**MPCA RESPONSE TO COMMENTS ON DRAFT
BEST AVAILABLE RETROFIT TECHNOLOGY MODELING PROTOCOL FOR
MINNESOTA
(Available for Public Comment October 10-November 4, 2005)**

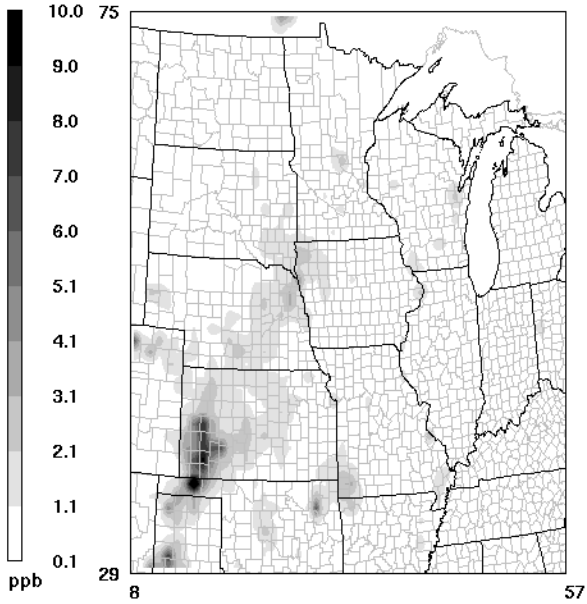
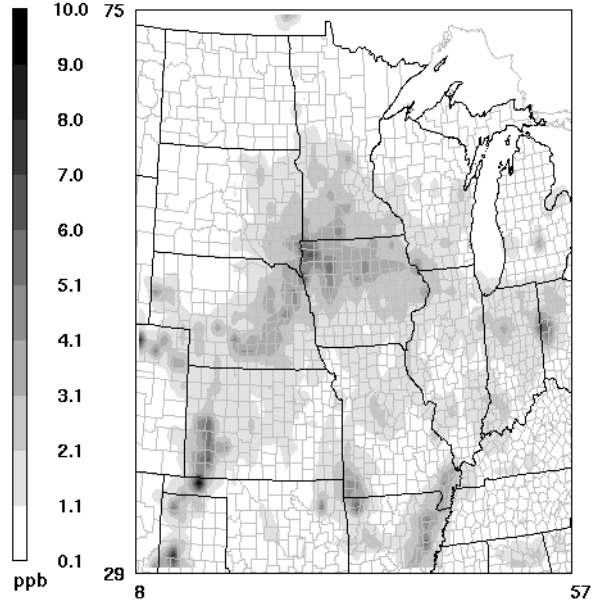
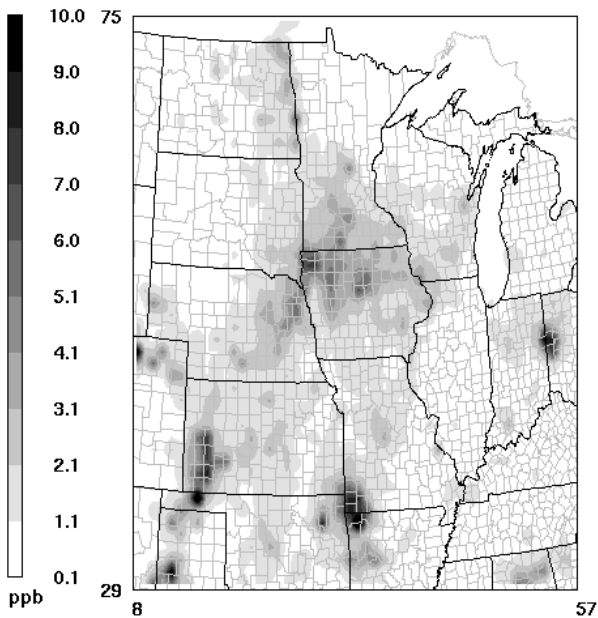
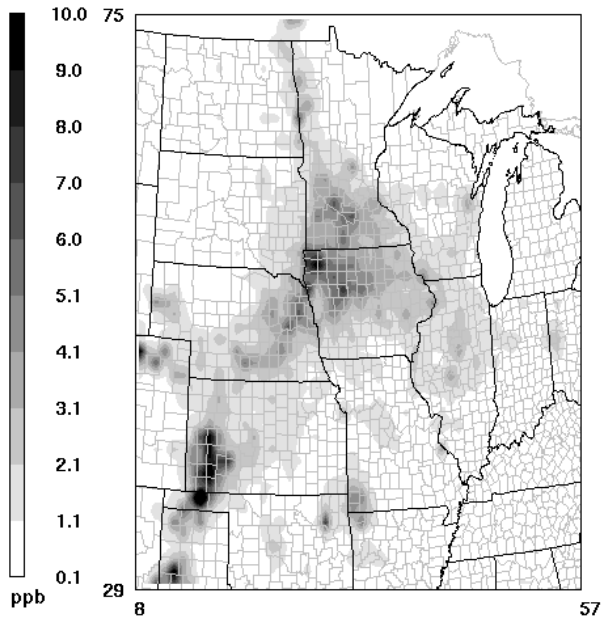
3. **Ozone, Ammonia and Hydrogen Peroxide data.** Two commenters requested that the MPCA use actual monitoring data for ambient ozone concentrations instead of using the modeled ozone concentrations proposed in the protocol. One commenter was concerned whether modeled ammonia is the best way to determine NH_3 concentrations. Because of a lack of ammonia data, the commenter recommended using observed monitoring data from the Bondville, Illinois site, which the commenter regards as a rural site without direct ammonia source influences. A third commenter suggested that the ammonia emissions reflect only Minnesota, instead of the entire domain.

Response. The MPCA was aware that the proposed ozone concentrations for the then proposed 4km domain—obtained from modeled data—appeared to be too high before public notice of the draft BART modeling protocol. It wasn't until after the draft BART modeling protocol was public noticed, however, that the MPCA was able to fix the error. There was a math error in the utility the MPCA used to extract the modeled ozone concentrations. This is the same utility used to extract the ammonia concentrations, as well. The corrected concentrations of ozone, ammonia are provided in the revised Table 7, below.

Because a commenter specifically suggested using the Bondville, Illinois observed ammonia values, the MPCA compared available ammonia monitoring data for late-2003 to mid-2005. Data is collected from the monitors every six days. The comparison was made using data from the Bondville site—and also from one southern Minnesota ammonia monitor—to modeled concentrations extracted from the 12-km grid cells in which those two monitors reside and in the 3x3 12-km grid cells surrounding the monitor. These results are tabulated below:

The monitor to model concentration comparison has fairly good agreement at the monitor site/grid cell location and the 3x3 grid cells surrounding the site. In addition, one must remember that the monitors collect data every six days, while the model simulates concentrations every day. The model can also simulate low concentrations that are below the monitors detectable limits. The model can capture spatial variations in ammonia concentrations that a monitor can not. Below are four plots of the modeled ammonia for each season, which were used for extracting the domain-wide averages. For all these reasons, the MPCA is comfortable with the domain-wide average for ammonia extracted from the model rather than using a particular monitored ammonia concentration.
